# 1988 - 1989 Corvette: Recall: Evaporative Emission Hoses

**Subject:** CAMPAIGN: EVAPORATIVE EMISSION HOSES

**Model and Year:** 1988-89 CHEVROLET CORVETTE

**Bulletin Number:** 89C25 - (08/23/1993)

FIGURE 1

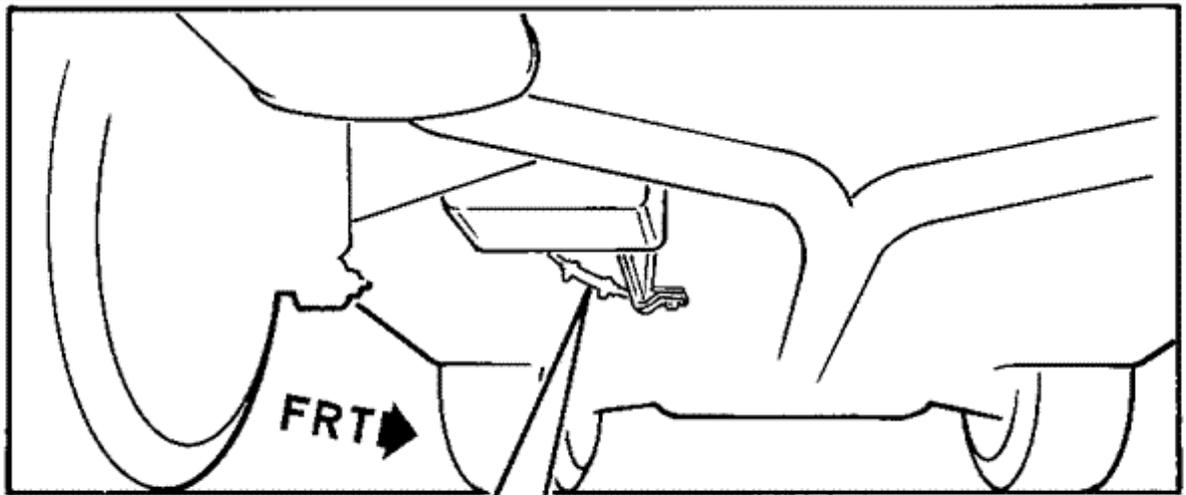
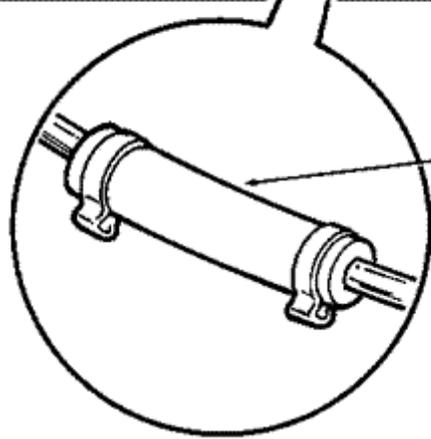
1. Raise vehicle.
2. Referring to Figure 1, locate rubber hose (approximately 2-9/16" long - 65mm) connecting fuel tank evaporative emission pipe to chassis fore-aft evaporative emission pipe.

3. Remove both hose clamps and hose. Hose clamps and hose will not be reused.
4. Inspect pipes and bend if required to insure ends of pipes are in line with one another.

5. Install two (2) new clamps (P/N 01622744) and new hose (P/N 09442928) onto pipe ends. Insuring hose is positioned an equal distance over both ends. Position clamps onto hose and secure.

HOSE MUST BE POSITIONED EQUALLY OVER BOTH PIPES

FIGURE 2

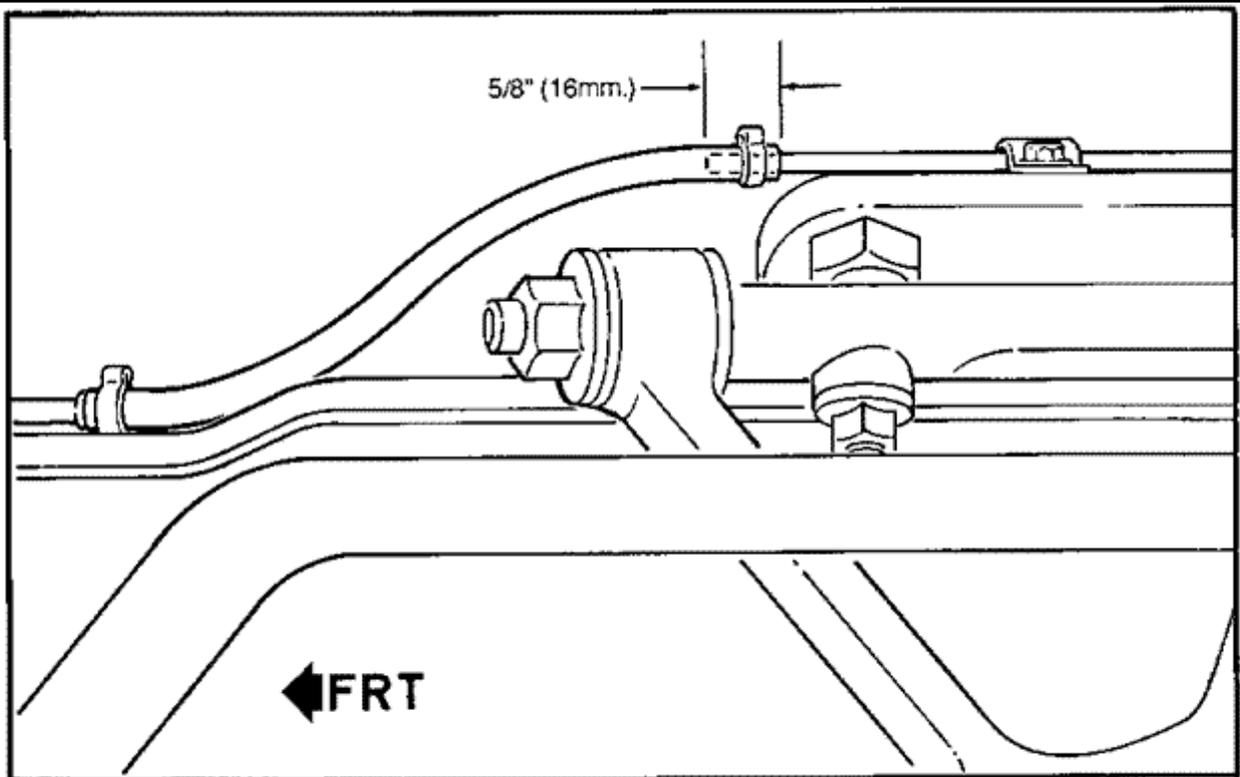
6. Lower vehicle.
7. Underhood, locate the evaporative emission hose connecting chassis fore/aft evaporative emission pipe to evaporative emission line shown in Figure 2.

8. Remove both hose clamps and hose. Hose clamps and hose will not be reused.
9. Install new large clamp (P/N 10028454) over nylon evaporative emission line, and install new small clamp (P/N 01622744) over chassis pipe.

10. Install larger end of new hose (P/N 10248651) over nylon evaporative emission line and install the opposite end approximately 1/2" over the fore/aft chassis pipe as illustrated in Figure 2.

**Notice: If hose appears taut when assembled as indicated above, repositioning of chassis fore/aft pipe may be required to alleviate condition.**
